**CERTIFICATE OF APPROPRIATENESS**

**Property:** 1323 Rutland, Lot 10/11A, Block 174, Houston Heights Subdivision. The property includes a historic 2,147 square foot, one-and a half-story single-family residence and an attached garage situated on a 6,600 square foot (50'x132') lot.

**Proposal:** Alteration -Addition, porch, windows, doors

HP2022\_0194  
 1323 Rutland St  
 New Project  
 Planner Assigned  
 Houston Heights East [Contributing]  
 Alteration [Addition, Doors, Windows, Porch or Balcony, Roof]  
 Single Family Residential

### FIRST FLOOR PLAN

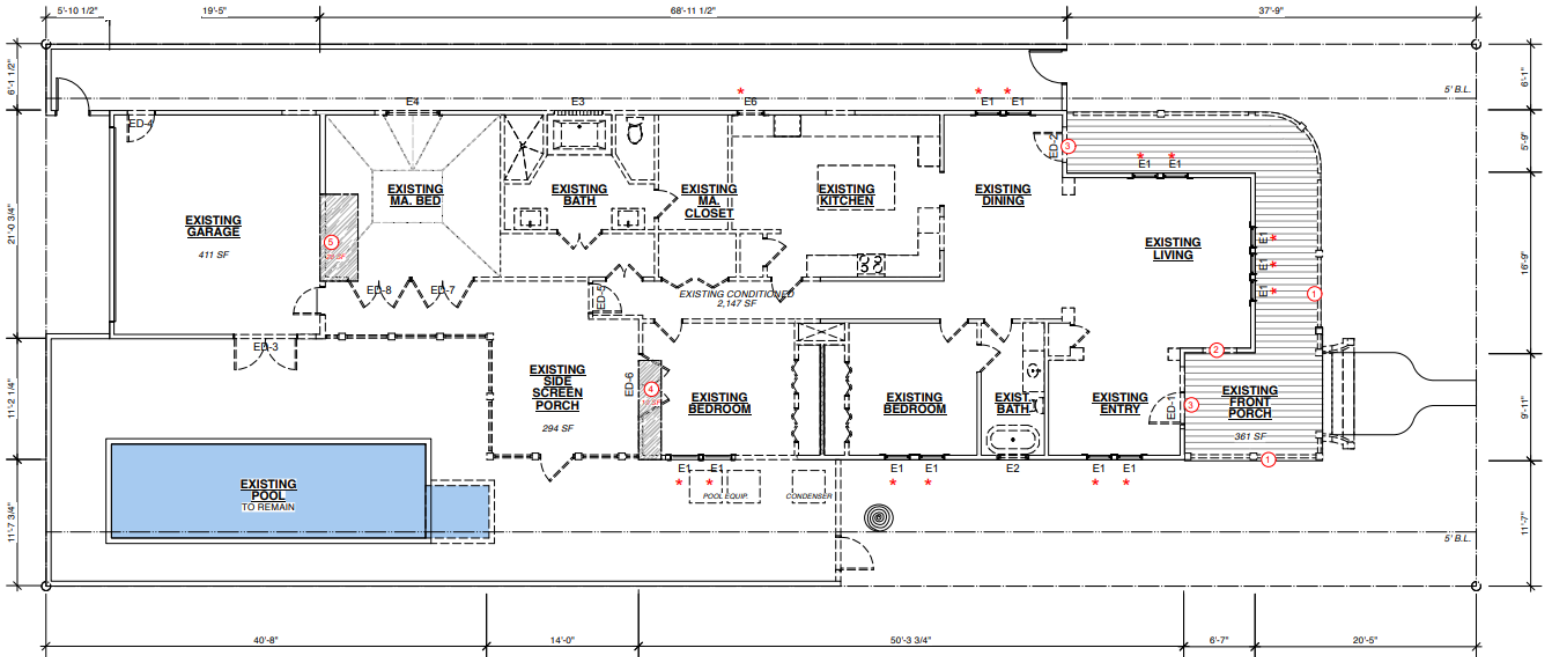
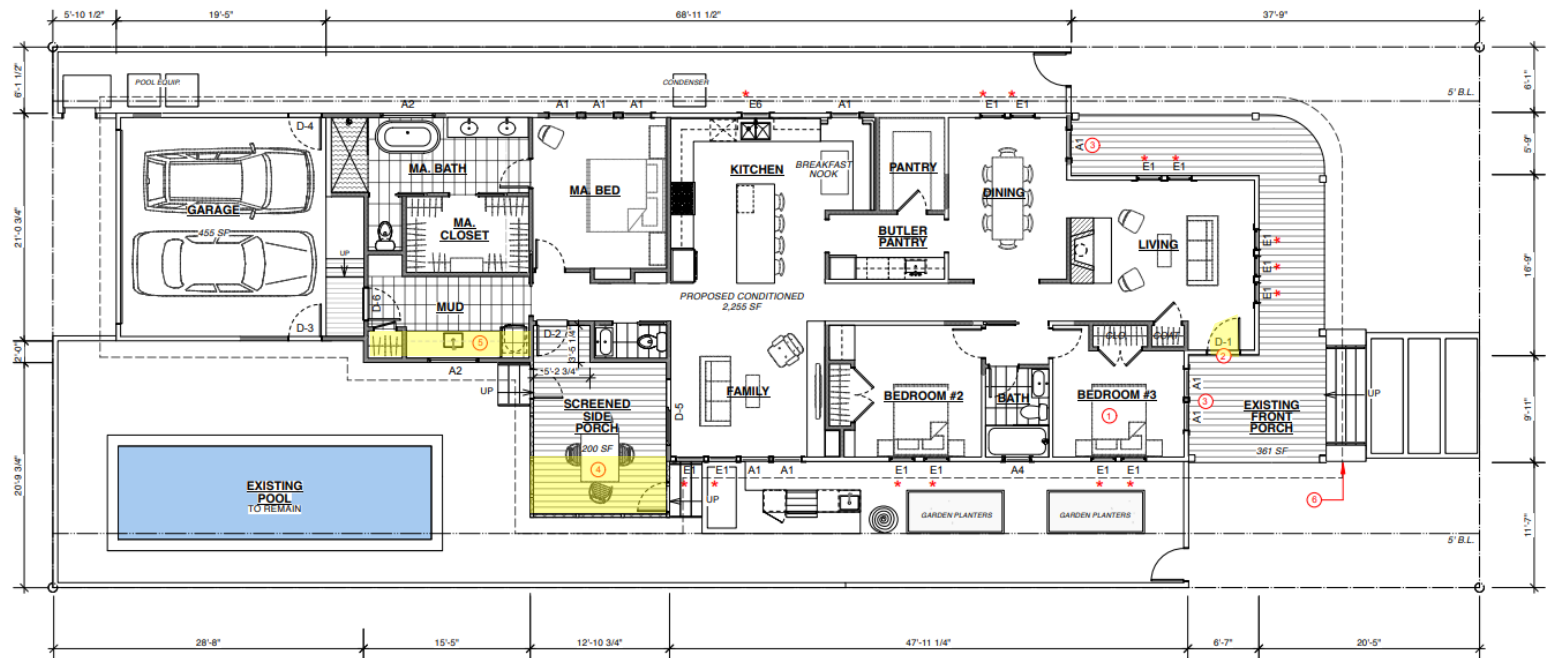
- **Reconfigure c. 1997 Addition, remove 47 square feet of existing living space and add 155 sq ft of living space back, as well as 44 square feet to existing one story garage.**
- **Alterations result in 2,255 sq ft of living space and 455 sq ft garage.**
- Revision alters addition's rear roofline and extends the 1968 addition roofline into a gable. Roof ridge height will not increase in height.
- Revise hipped gable roofline over master bathroom/Laundry to gabled roof.
- Move garage access door location (not visible from street).

**EAST ELEVATION – FRONT FACING RUTLAND**

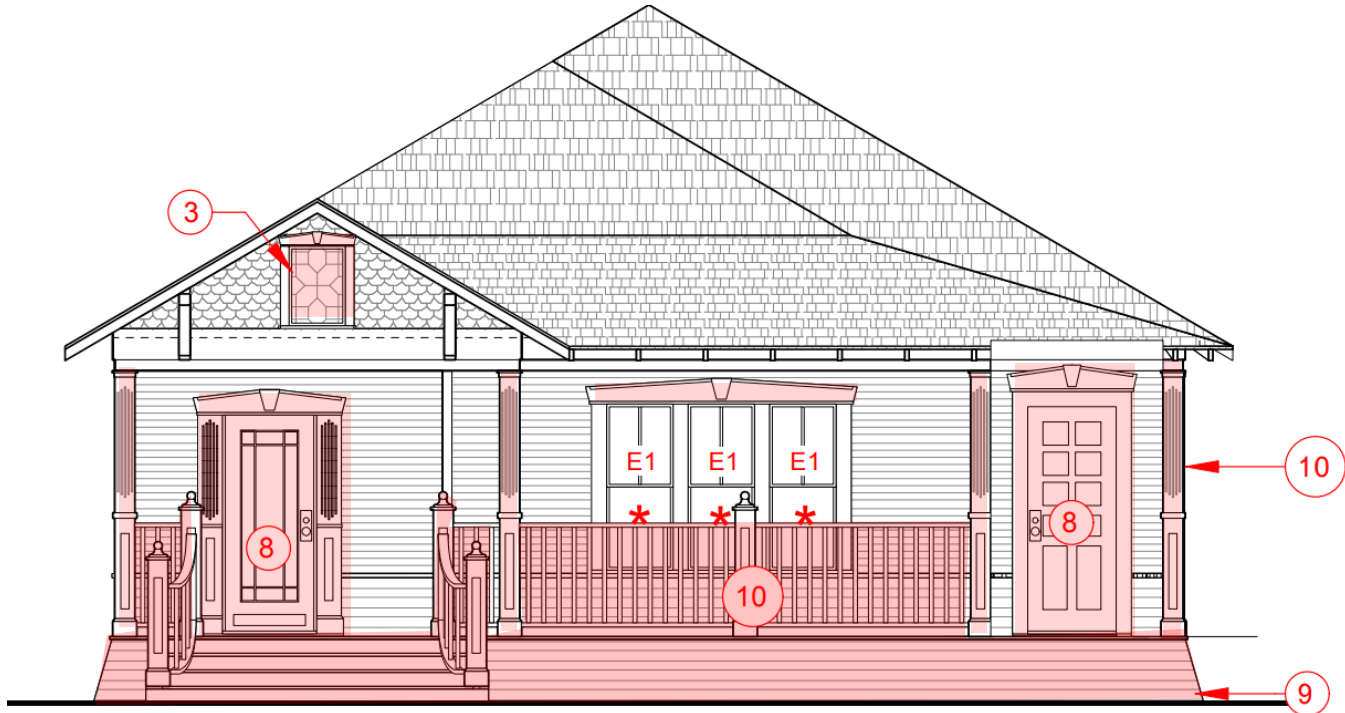
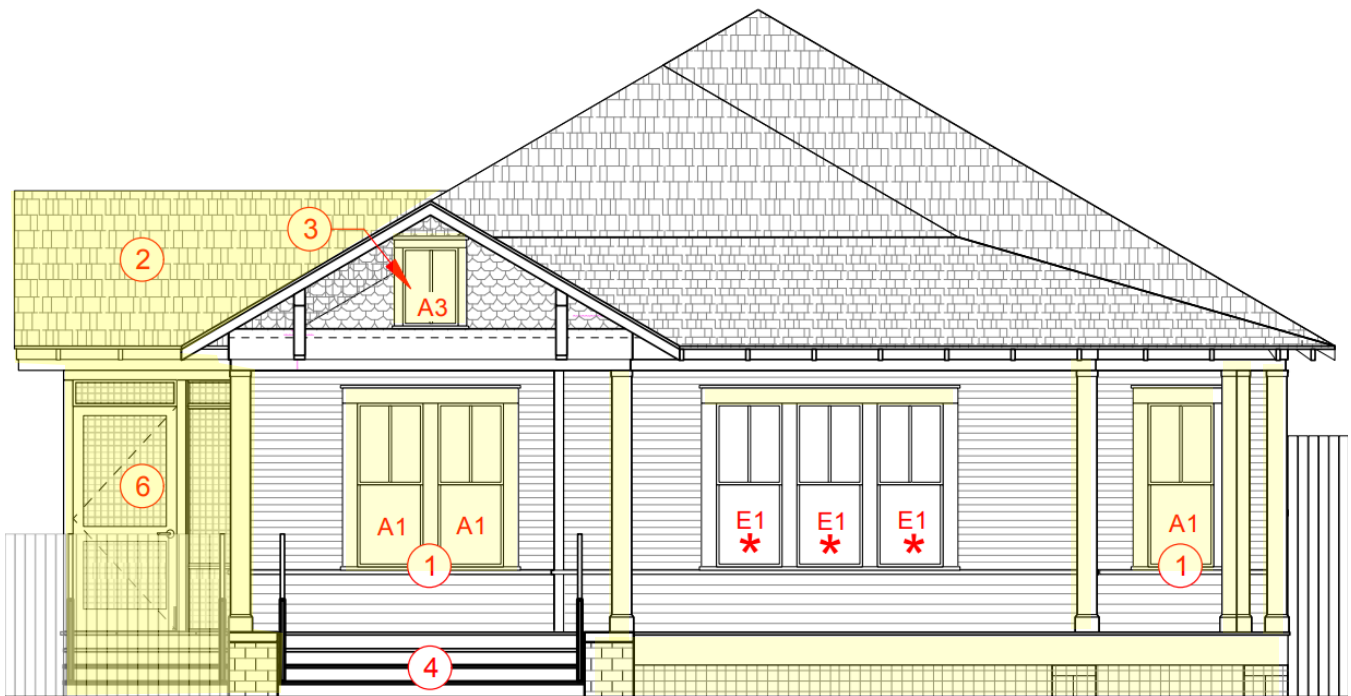
**East Elevation - Front Porch** (this wraps around to the north and south)

- Remove guard/handrails/stairs and replace with new wood steps with side brick walls. Include simple steel handrail per code.
- Remove existing secondary entry door at back northwest side of porch with a wood double hung window to match existing windows.
- Replace stained glass window (c.1997) at front roof gable with fixed wood window.
- Front Entry Door: Relocate east (street) facing entry front door to south facing location.
- Replace current door location with double windows to match existing replacements c.1997.

**WEST SIDE ELEVATION (REAR)**

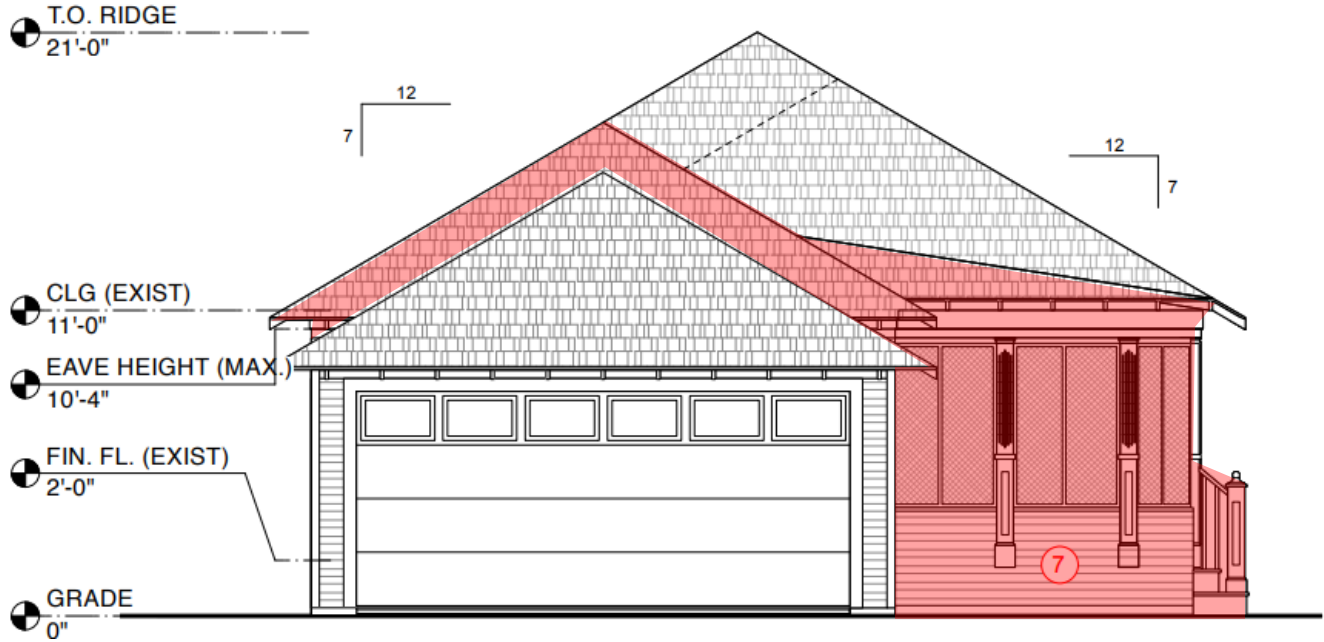
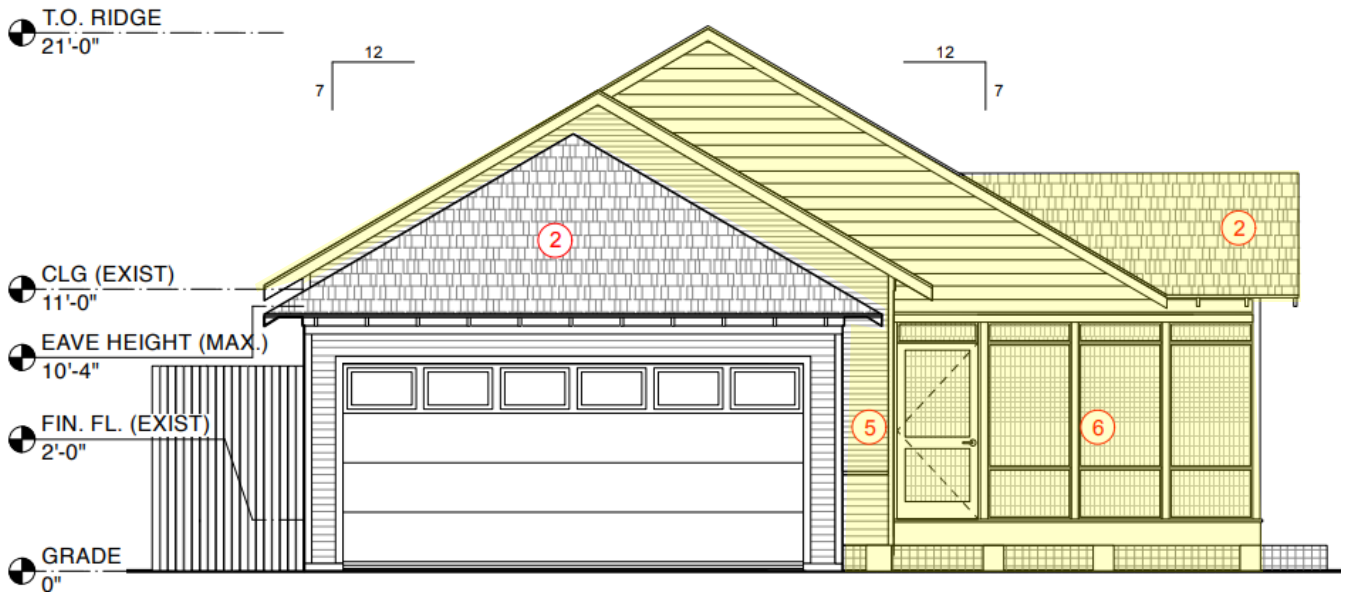
**Rear Alteration/Addition (one story)**

**NORTH SIDE ELEVATION  
EXISTING**

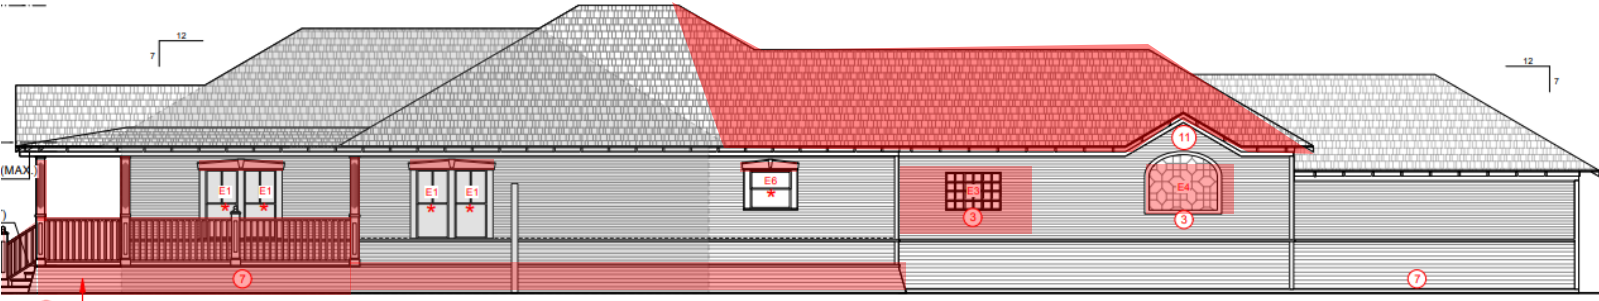
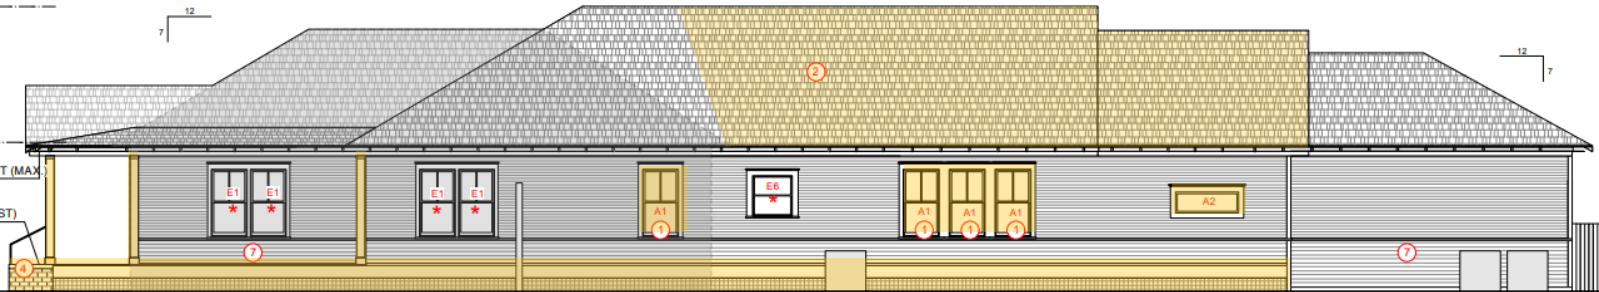
- Remove non historic glass block and faux stained-glass windows and replace with window to match current replacements in 2/1 or 1/1. Any changes in opening are on the rear or non-historic addition.
- Remove existing screened porch/columns detailing and replace with slightly expanded footprint to the south in simplified design.

CURRENT -NORTH ELEVATION WINDOWS – TO BE REMOVED
